Number: SB 500-21-003, Rev B
Model: ECLIPSE EA500
Subject: Integrated Twin Pack Compressor Pallet Assembly
(ITPCA) Inspection/Repair

To improve the thermal operating margin of the primary power interface connection between the controller and each of the compressors

This Service Bulletin provides the aircraft effectivity and replacement of the controller to compressor power electrical interface slide connector located in the controller assembly of the ITPCA.

Figure 1

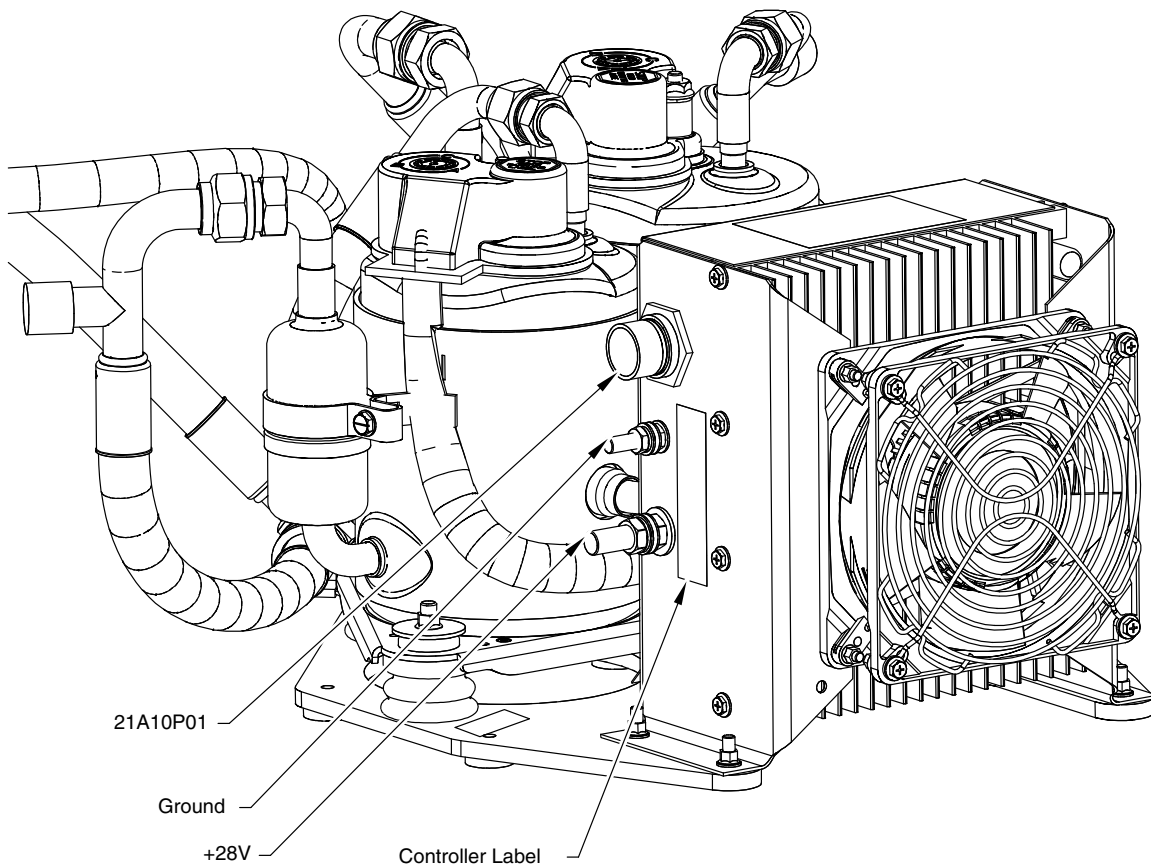
- (3) Ensure the VCS system is turned off and secured from operation during the implementation of this service bulletin. _____
- (4) Disconnect the 21A10P01 Connector at the ITPCA controller. Refer to [Figure 1](#). _____

- (5) Remove Mox Tape, lock nut and washers from the +28V stud on the ITPCA controller. Remove and secure cable CCS-1006-6 as required. Use a backup wrench as needed to ensure the power stud does not turn when removing the ring terminal hold down nut. Retain hardware for reinstallation. Refer to [Figure 1](#). _____

- (6) Remove Mox Tape, lock nut and washers from the Ground stud on the ITPCA controller. Remove and secure cable CCS1010-6N as required. Use a backup wrench as needed to ensure the ground stud does not turn when removing the ring terminal hold down nut. Retain hardware for reinstallation. Refer to [Figure 1](#). _____

Figure 2

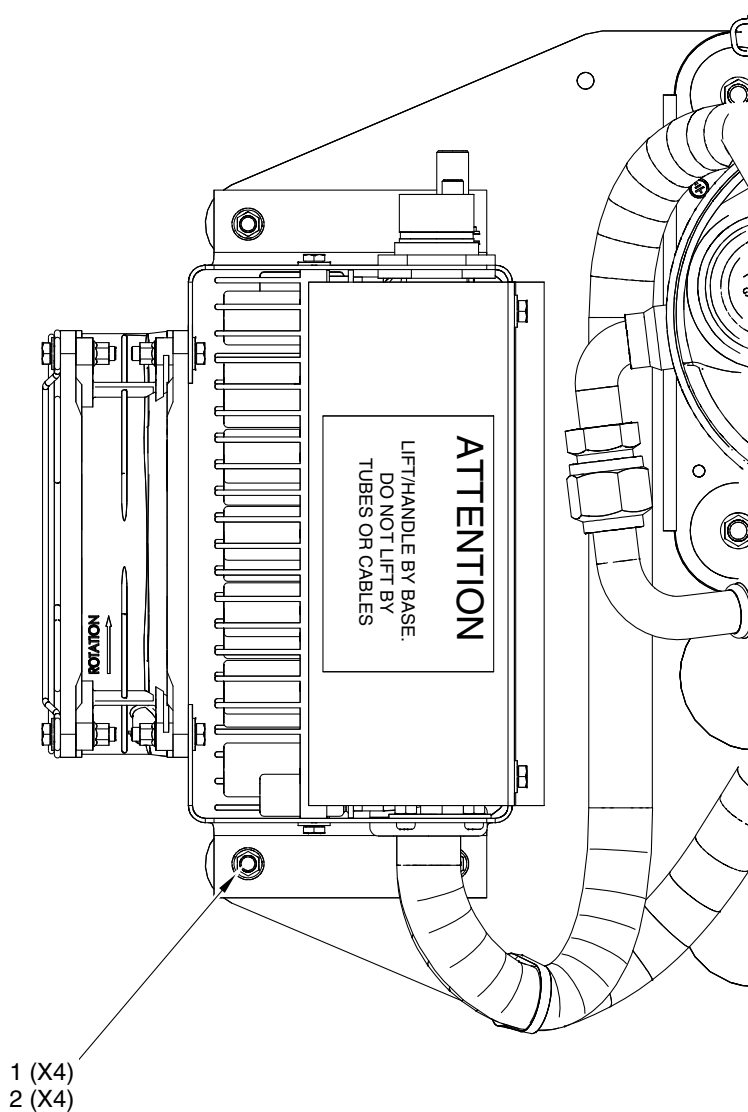
- (7) To aid in removing and accessing the compressor primary power interface slide connectors in the controller, it is permissible to loosen and remove the four nylon lock nuts, P/N MS21044N3 (1, Figure 2) and flat washers, P/N NAS1149F0332P (2, Figure 2) securing the controller to the ITPCA base plate. Retain the four lock nuts and the four flat washers for reinstallation.

Figure 3

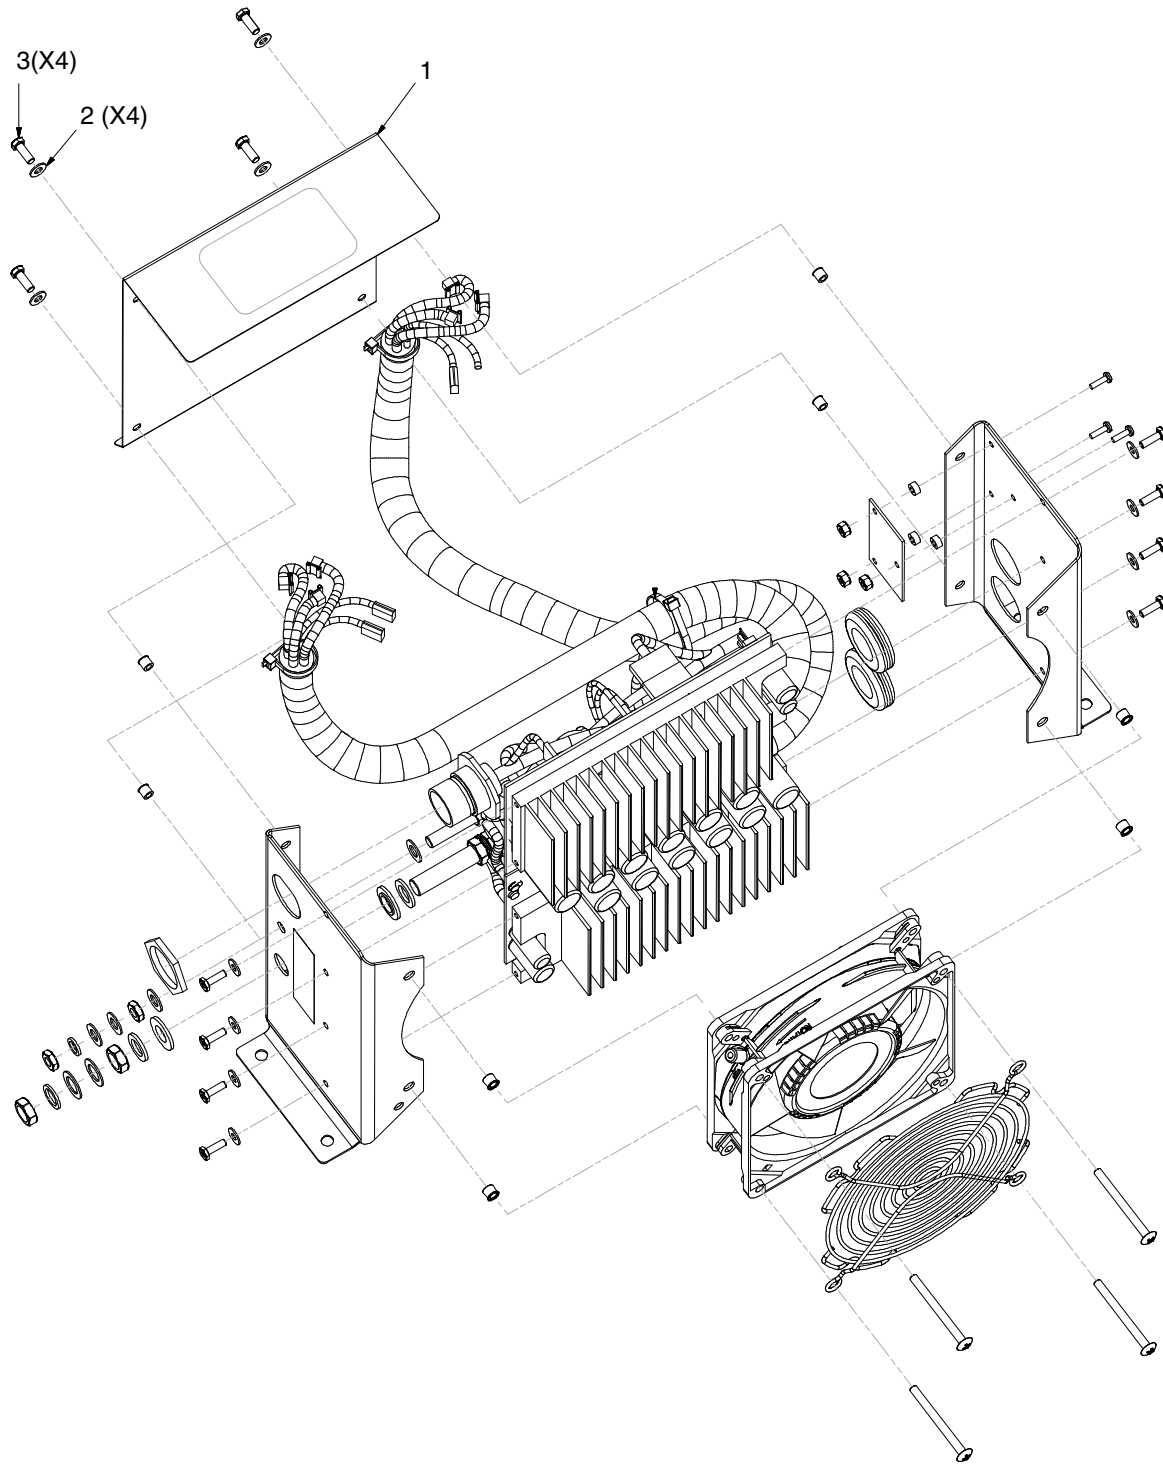
- (8) Turn controller assembly as required to access the four screws retaining the back cover on the controller assembly. It is permissible to cut the tie wraps that may be securing the compressor power cable assemblies to each other to aid in manipulating the controller to a better working position. It is not required to disconnect the power cables from each of the compressors. Keep a record of which tie wraps were cut so they can be replaced later.
- (9) Remove four screws, P/N NAS1801-06-6 (3, Figure 3) and four flat washers, P/N NAS1149CN632R (2, Figure 3) that secure the back cover (1, Figure 3) to the controller. Retain back cover and fasteners for reinstallation.

- (17) Reinstall the back cover (1, Figure 3) with four screws, P/N NAS1801-06-6 (3, Figure 3) and four flat washers, P/N (2, Figure 3) removed earlier. Torque screws to 12 in-lbs.
- (18) While rerouting the cables back to each compressor, resecure the controller assembly to the four mounting studs with the four lock nuts, P/N MS21044N3 (1, Figure 2) and four flat washers, P/N NAS1149F00332P (2, Figure 2) removed earlier. Torque lock nuts to 19 in-lbs plus drag torque.
- (19) The compressor power cables should be routed as shown. Replace any tie wraps removed earlier with tie wraps, P/N MS3667-4-0 or equivalent (1, Figure 10).

Figure 4

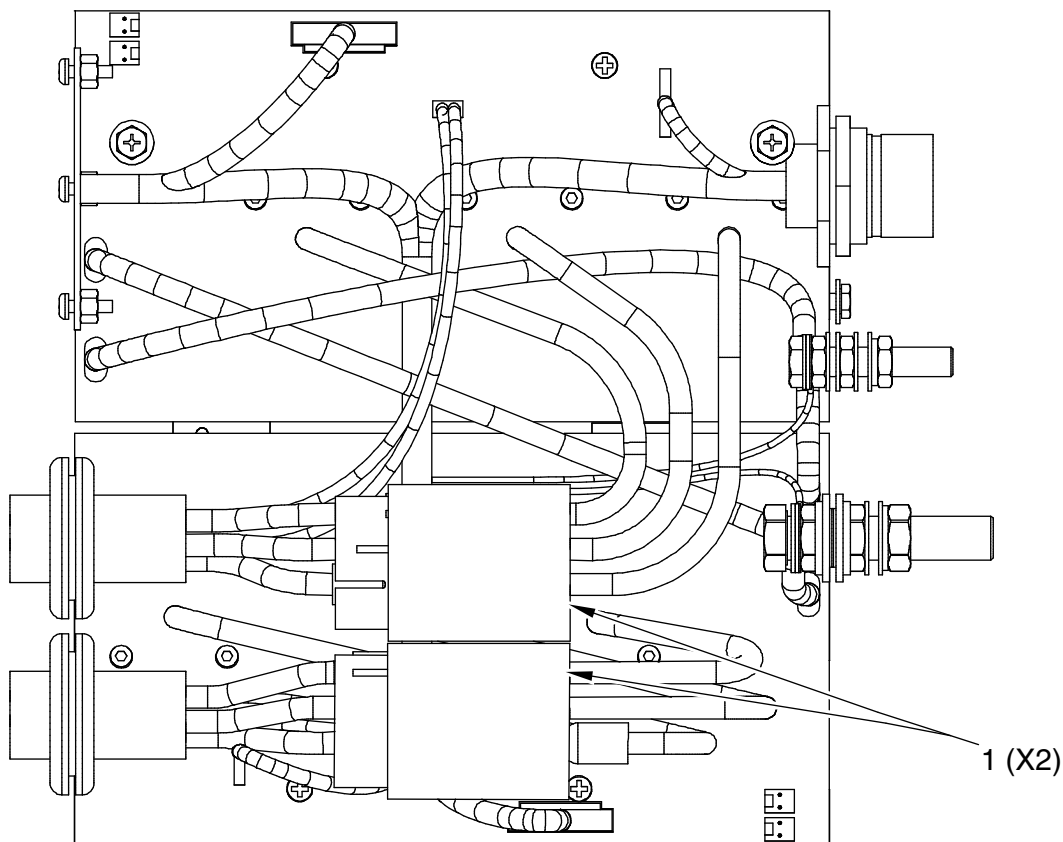
- (10) Each power cable assembly to each compressor is made up of 5 conductors. The three large conductors are the power conductors which terminate at the large black slide connectors (1, Figure 4). The two smaller conductors are signal conductors. Do not cut or change the two small conductors.

With a pair of appropriate wire cutters, cut each of the three large conductors on each side of the large interface connector (1, Figure 4) as close to the connector as possible. A total of 12 wires shall be cut, 6 associated with each compressor. Remove and discard the black slide connectors (1, Figure 4).

NOTE: If evidence of wire, connector or terminal overheating is discovered. Remove and replace ITPCA. Refer to AMM - 21-10-11 - INTEGRATED TWIN PACK COMPRESSOR ASSEMBLY - REMOVAL and AMM - 21-10-11 - INTEGRATED TWIN PACK COMPRESSOR ASSEMBLY - INSTALLATION.

Figure 8

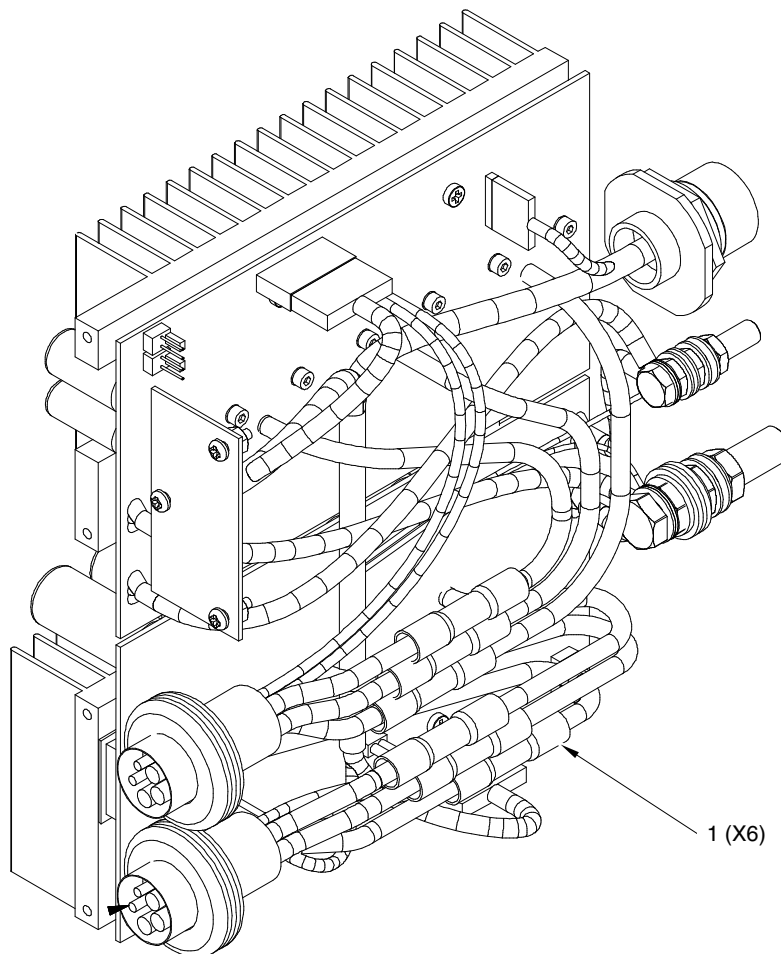
- (11) Strip insulation from each of the colored (blue, orange and yellow) wires 5/16". Match up the wire colors and insert each wire into the applicable crimp barrel of the RAYD-406-0003 butt splice connector. There is sufficient "slack" in the cable assembly to each compressor to make the connection. Refer to Figure 5 and Figure 8.

- (14) Repeat steps 11 – 13 as required until all 6 pairs of conductors have been spliced together as depicted in [Figure 8](#).

Figure 9

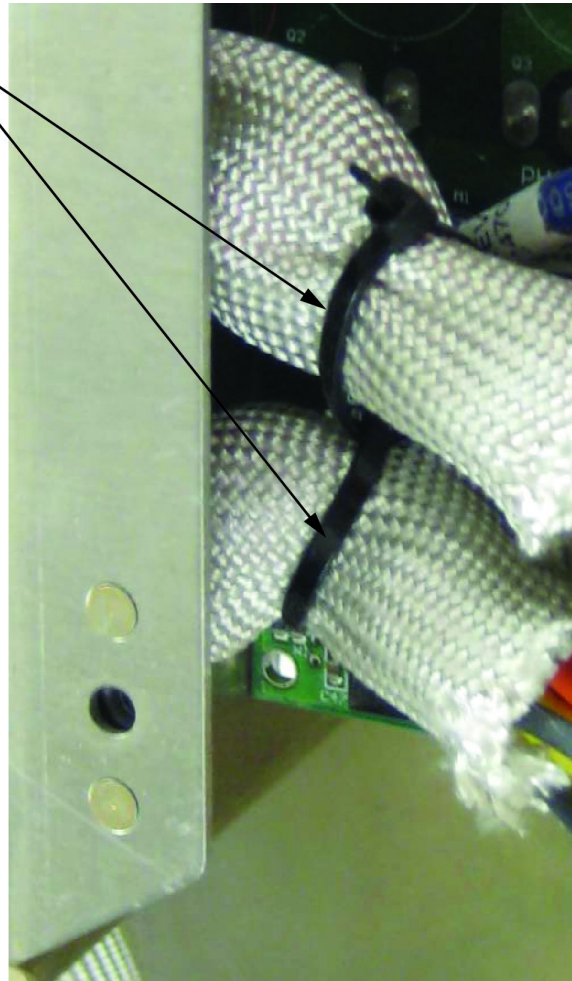
(16) Install two tie wraps, P/N MS3667-4-0 or equivalent (1, Figure 9) around the braided sleeving near where the cables exit the side of the controller box. Install the tie wraps in such a way so that one tie wraps loop through the other is a daisy chain fashion. Cinch both tie wraps down to assist in “tucking” the cable assemblies into the enclosure as noted to support cable routing before the back cover is reinstalled.

Figure 11

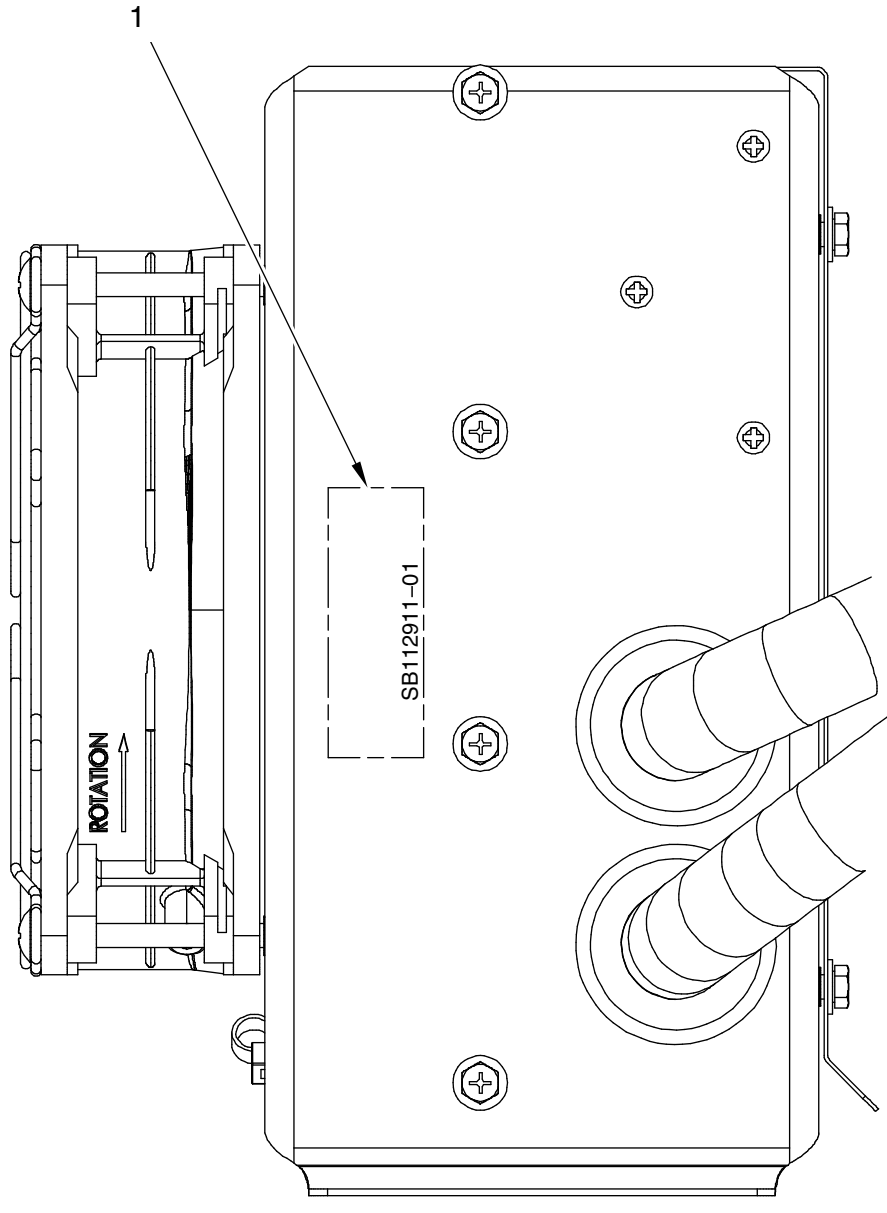
- (23) Final Inspect work completed. _____
- (24) Do a Adjustment/Test of the ITPCA. Refer to AMM - 21-00-00-A - AIR CONDITIONING - ADJUSTMENT/TEST or AMM - 21-00-00-B - AIR CONDITIONING - ADJUSTMENT/TEST. _____
- (25) With a fine point indelible marker, signify the completion of this service bulletin by printing neatly "SB 500-21-003" in the space available on the controller label (1, Figure 11). _____
